# Service Bulletin

Inspection and modification of Strut Pick-up ribs – Rib no. 5 and Rib no. 6

This Service Bulletin is applicable to the aircraft identified in Table 1.

**Figure 6: Fuselage Skin Modification**

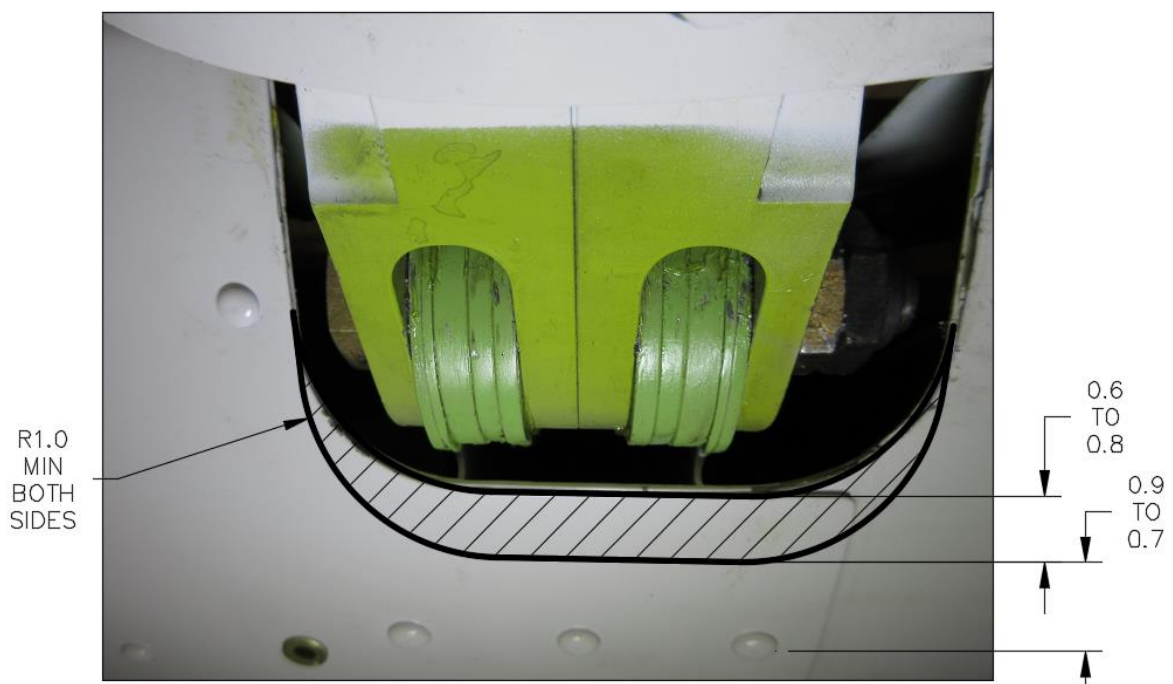
- a. Enlarge the cut out in the Forward Cabin Belly Skin (P/N GA8-533021-113), Aft Cockpit Belly Skin (P/N GA8-533021-111) and Fuselage Strut Skin Doubler (P/N GA8-533022-095) to the dimensions shown in Figure 6.
- b. De-burr and finish all blended edges with a Scotch-Brite® pad or similar to achieve a surface finish of at least 125 microinch Ra (3.2 micron Ra).

**Figure 7: Fuselage Rib Modification.**

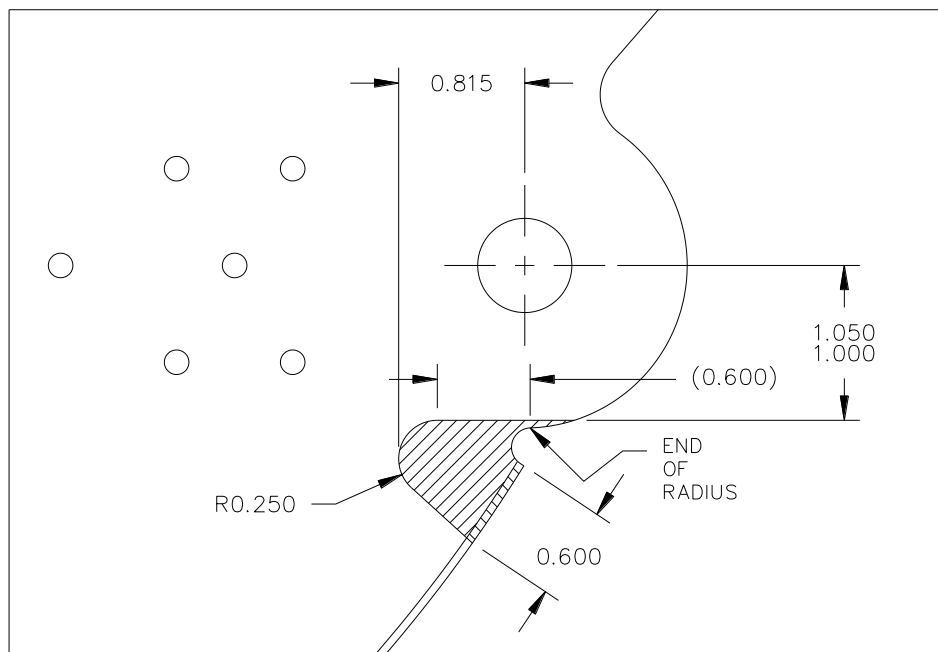
- Remove material in the shaded area by blending to achieve the dimensions shown in Figure 7.
- De-burr and finish all blended edges with a Scotch-Brite® pad or similar to achieve a surface finish of at least 125 microinch Ra (3.2 micron Ra).

**REMOVE ALL OF THE MATERIAL INDICATED. DO NOT APPLY A PARTIAL BLEND.**

**Figure 30: Floor Skin to be Trimmed. LHS Shown, RHS Opposite.**

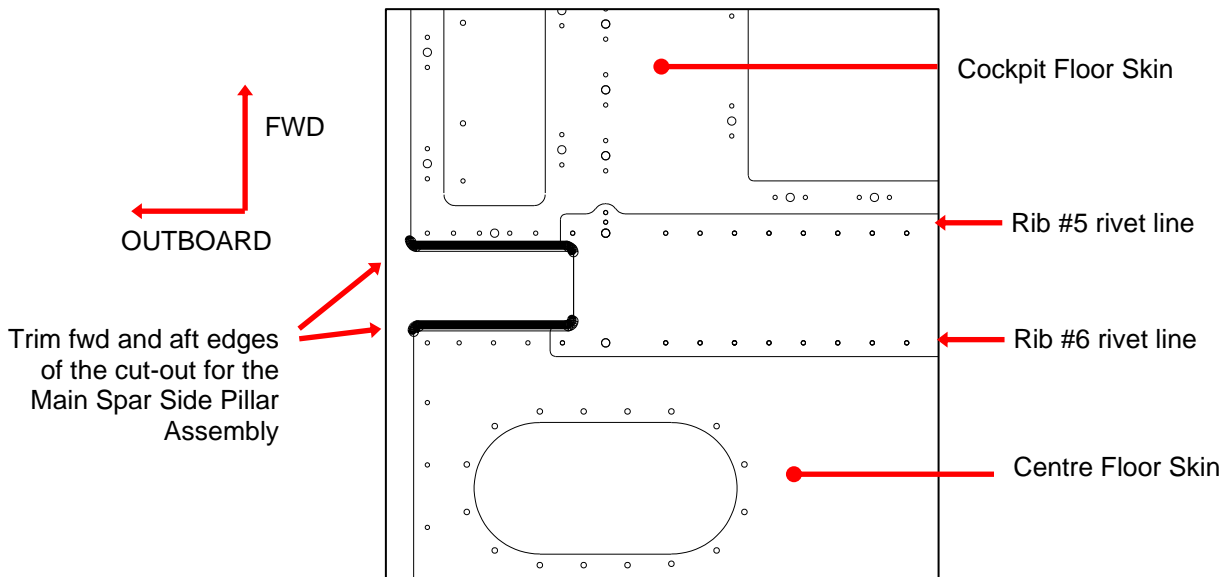
- a. Trim aft edge of Cockpit Floor Skin by 0.100" +/- 0.005" as shown in Figure 30.
- b. Trim forward edge of Centre Floor Skin by 0.100" +/- 0.005" as shown in Figure 30.
- c. De-burr and finish all blended edges with a Scotch-Brite® pad or similar to achieve a surface finish of at least 125 microinch Ra (3.2 micron Ra).
- d. Prime the exposed metal using Compound C1 (Table 7).

**Figure 35: Trimming of Floor Attach Angle.**

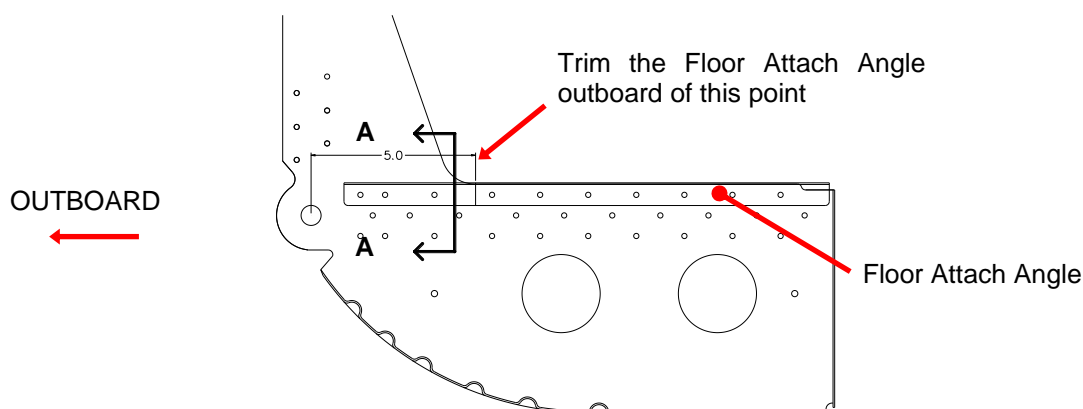
- i. Trim away  $0.100'' \pm 0.005''$  on the outboard end of the vertical leg of the Floor Attach Angle (GA8-532021- 33/34) as shown in hatched area of Figure 36 for a length of  $5.0'' \pm 0.100''$  inboard of the rib lug end bore (Figure 35).

**Figure 37: Rib Modification**

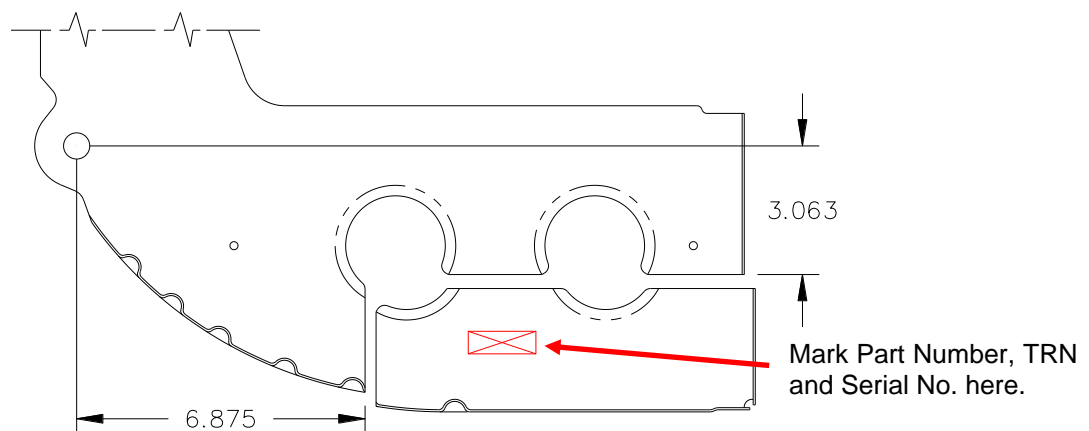
- d. Cut the parts as shown in Figure 37. De-burr and finish all blended edges with a Scotch-Brite® pad or similar to achieve a surface finish of at least 125 microinch Ra (3.2 micron Ra).

**Figure 41: Doubler Installation Locations – Rib 5**

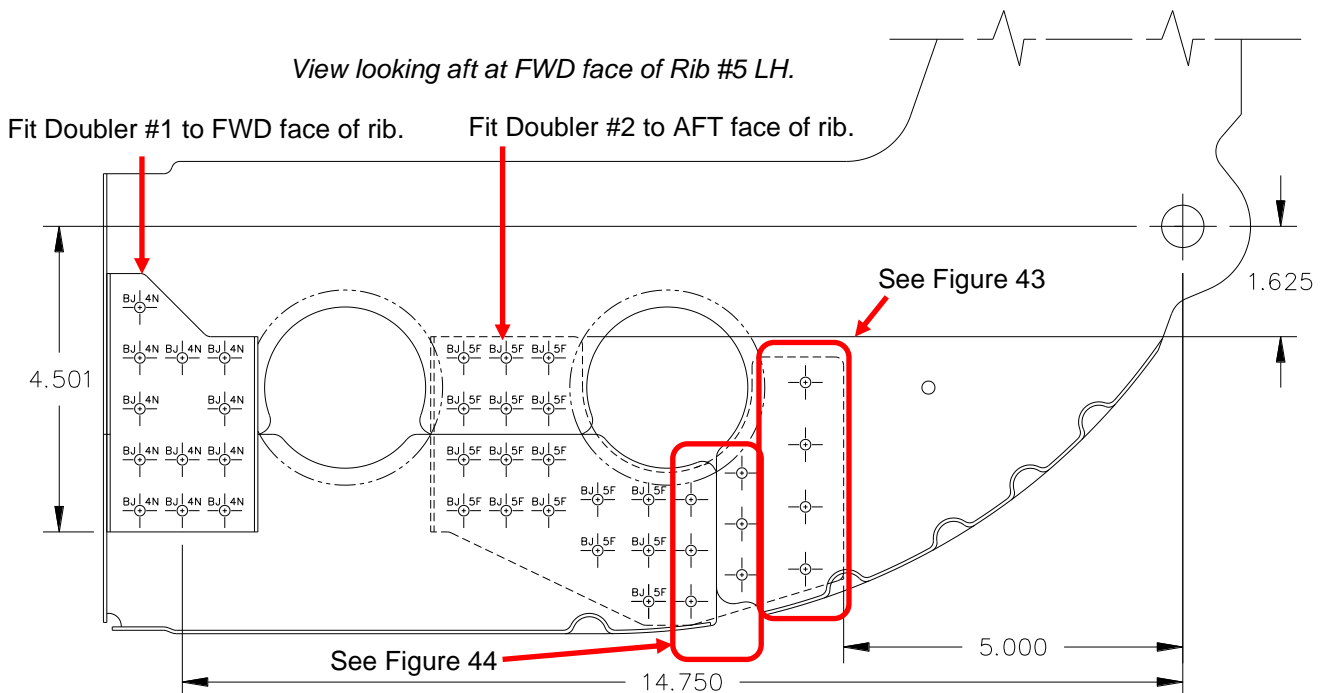
- c. Locate the doublers on the ribs as shown in Figure 41 and Figure 42. Transfer the hole locations from the doublers to the ribs. Drill ribs and doublers to a pilot hole size (0.098" nominal).

- iii. For ribs which **were** modified in accordance with Section 12.3.18, rivet the doublers to the ribs as shown in Figure 41, Figure 42, Figure 43 and Figure 44.

**Figure 45: Cockpit Door Aft Gusset modification.**

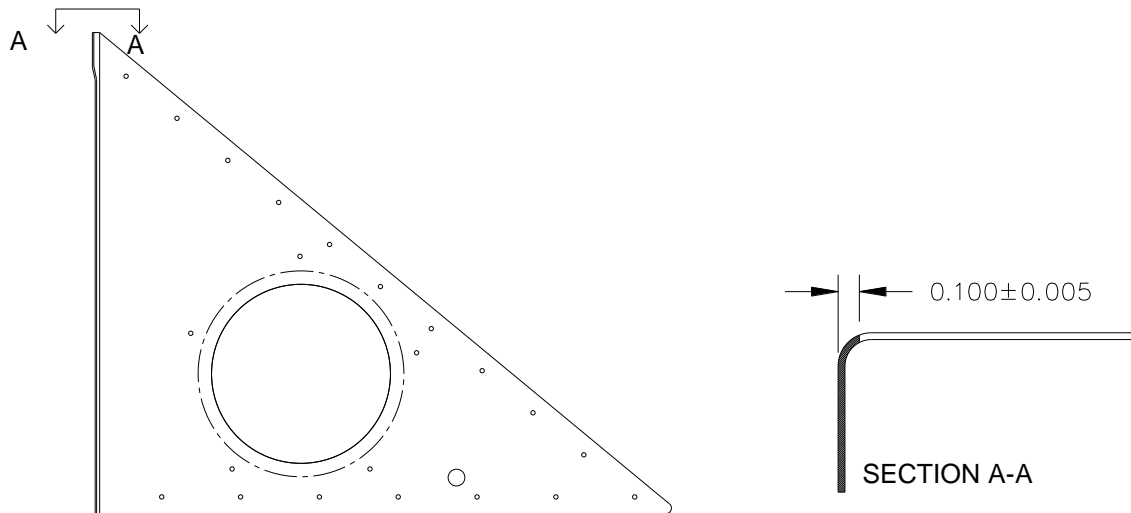
- a. Trim the aft end of the Cockpit Door Aft Gusset(s) by 0.100" +/- 0.005" in the hatched area of Section A-A of Figure 45.
- b. Prime the exposed metal using Compound C1 (Table 7).
